SUBJECT: AMENDMENT NO. 109 TO FACILITY OPERATING LICENSE NO. DPR-50

METROPOLITAN EDISON COMPANY
JERSEY CENTRAL POWER AND LIGHT COMPANY
PENNSYLVANIA ELECTRIC COMPANY
GPU NUCLEAR CORPORATION
DOCKET NO. 50-289
THREE MILE ISLAND NUCLEAR STATION, UNIT NO. 1
AMENDMENT TO FACILITY OPERATING LICENSE

ATTACHMENT TO LICENSE AMENDMENT NO. 109

SAFETY EVALUATION BY THE OFFICE OF NUCLEAR REACTOR REGULATION
SUPPORTING AMENDMENT NO. 109 TO FACILITY OPERATING LICENSE NO. DPR-50

FIGURE 3.11-1

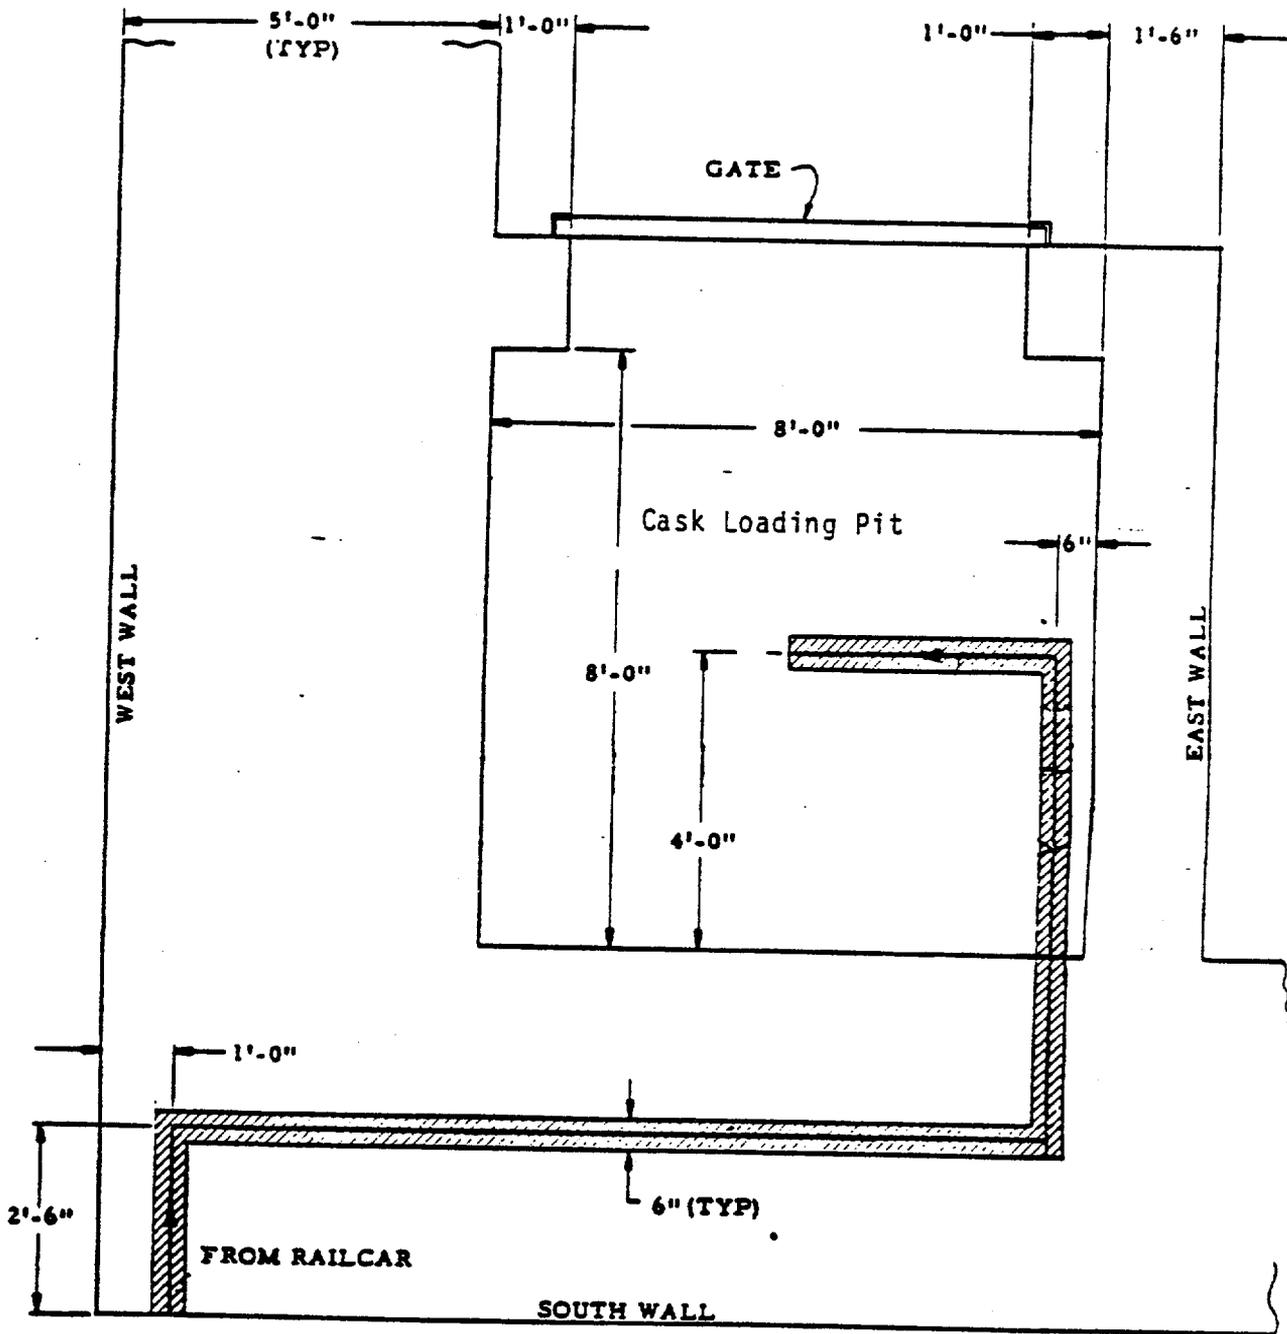
- 3.11.7 During transfer of the cask to and from the cask loading pit, the cask will be restricted to the transfer path shown in Figure 3.11-1. Administrative controls will be used to ensure that all lateral movements of the cask are performed at slow bridge and trolley speeds. During this transfer the cask lifting yoke shall be oriented in the East-West direction.

Specification 3.11.7 in combination with 3.11.3 ensures the spent fuel cask is handled in a manner consistent with the load drop analysis⁽²⁾.
